IEEE P802.15 Wireless Personal Area Networks

Project	IEEE P802.15 Working Group for Wireless Personal Area Networks (WPANs)	
Title	TG3 D10 running comment resolutions	
Date Submitted	[8 July, 2002]	
Source	[James P. K. Gilb] [Apparent Technologies] [9921 Carmel Mountain Rd. #247, San Diego, CA 92129]	Voice: [858-538-3903] Fax: [858-538-3903] E-mail: [gilb@ieee.org]
Re:	[]	
Abstract	[This document is a record of comment resolutions for LB17.]	
Purpose	[To provide a record of the comment resolution for LB17.]	
Notice	This document has been prepared to assist the IEEE P802.15. It is offered as a basis for discussion and is not binding on the contributing individual(s) or organization(s). The material in this document is subject to change in form and content after further study. The contributor(s) reserve(s) the right to add, amend or withdraw material contained herein.	
Release	The contributor acknowledges and accepts that this contribution becomes the property of IEEE and may be made publicly available by P802.15.

1. Comment resolution, Vancouver to Schaumburg

Figure 1—MSC for a approved asynchronous channel time request

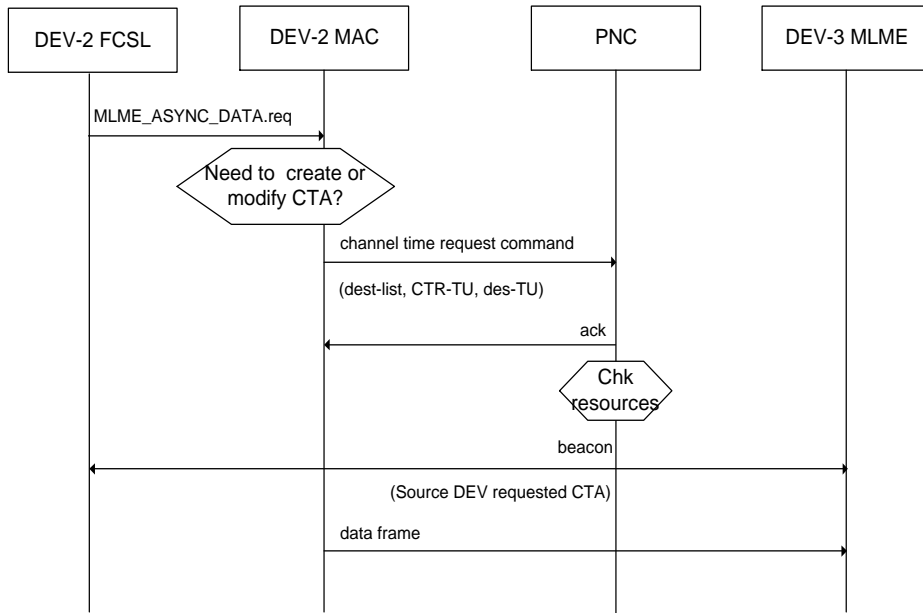
914 (Bain, T) In figure 119, The PNC DME has the task of building the beacon. However, in the isochronous operation figures, the PNC MLME is shown to be building the beacon. Consequently, change the location of the build beacon element to the PNC MLME. **Suggest accept in principle** per CID 327

327 (Heberling, TR) Figure 119 is a flawed MSC of the Asynchronous channel time reservation process and data frame exchange. Consequently, delete the current MSC from this section of clause 8.5.2.1 and replace it with 02r0P802-15_TG3-Asynch-channel-time-allocation.eps. **Suggest accept**.

Figure 119 – MSC for reserving asynchronous data channel time. Discussed earlier, new MSC is below:
